DOCKETED	
Docket Number:	25-BSTD-03
Project Title:	2028 Energy Code Pre-Rulemaking.
TN #:	271012
Document Title:	Covered Process Refrigeration Final CASE Team Comment Letter
Description:	Final CASE Team Comment Letter - Covered Process Refrigeration.
Filer:	Michael Shewmaker
Organization:	California Energy Commission
Submitter Role:	Commission Staff
Submission Date:	6/25/2026 2:12:57 PM
Docketed Date:	6/25/2026

2028 TITLE 24 REFRIGERATION COMMENT LETTER

Docket No. 25-BSTD-03

Figure 1: Examples of Screw Compressor Variable V_i and Capacity Slide Positions

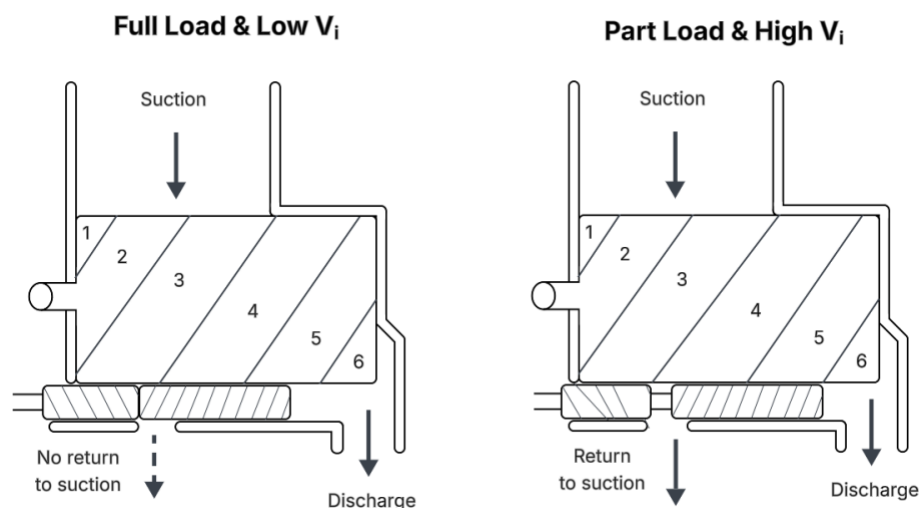
Though beneficial in many applications, variable V_i also introduces new clearances into the compressor, which create an internal leakage path. The performance penalty for these clearances is disproportionately higher for smaller compressors.

The diminished net benefit of variable V_i for smaller compressors has become more relevant in recent years as the industry shifts from custom-designed, field-erected central refrigeration plants to modular low-charge package systems. Today the screw compressors in these packaged systems are commonly equipped with motors in the range of 75 to 250 motor hp.

- 1) Change the requirement threshold from motor hp to compressor displacement. The proposed value is 450 cubic feet per minute (cfm), which is effectively equivalent for the application prototypes and compressors considered when the requirement was adopted in 2013.
- 2) Exempt transcritical CO₂ compressors from the requirement.

Figure 2: Highlighting of California Climate Zones 9 through 15

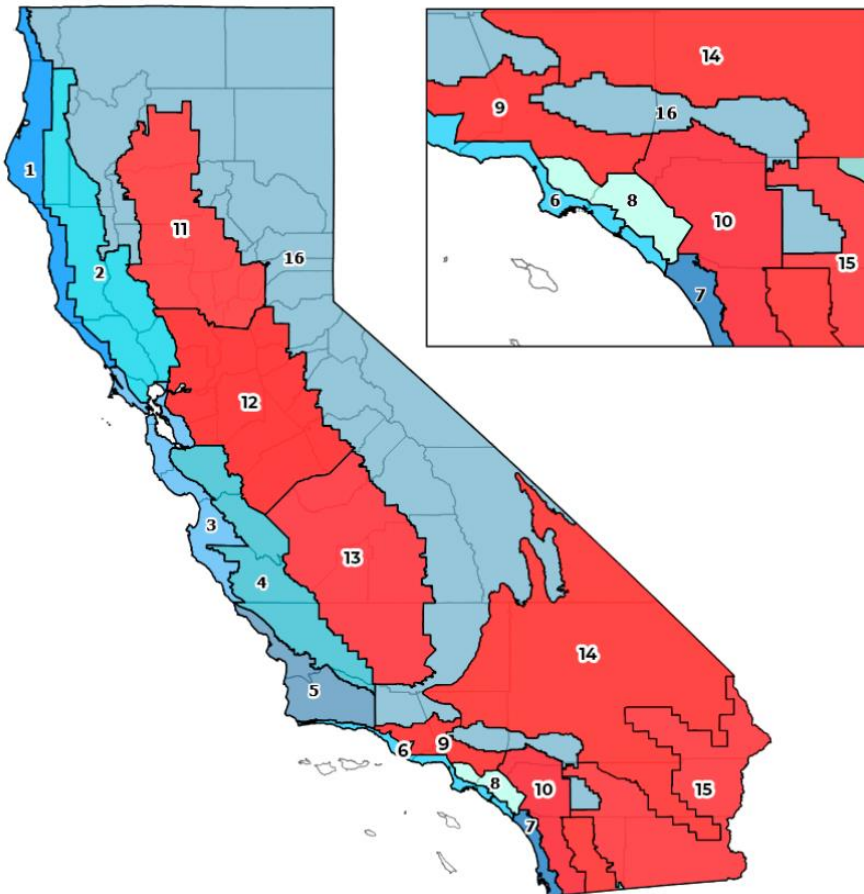
Since 2022, Title 24 prohibits the use of air-cooled gas coolers in transcritical CO₂ refrigeration systems in Climate Zones 9 through 15 for refrigerated warehouses and Climate Zones 10 through 15 for commercial refrigeration. This effectively requires use of adiabatic gas coolers in these climate zones. It is unclear whether spray and mister technologies comply with this prohibition of air-cooled gas coolers.

Figure 2 highlights Climate Zones 9 through 15 for refrigerated warehouses. Note that these Climate Zones represent the Central Valley and the inland portions of Southern California, which are the hottest areas of the state.

- 1) Remove the prohibitions of air-cooled gas coolers (Sections 901.1.8.1 [120.6(a)8A] and 902.1.5.1 [120.6(b)5A])
- 2) Require air-cooled gas coolers in Climate Zones 9-15 for refrigerated warehouses and Climate Zones 10-15 for commercial refrigeration to have a design leaving gas temperature less than or equal to the design dry-bulb temperature plus [TBD]°F, which shall represent equivalent annual energy performance through added surface area.¹
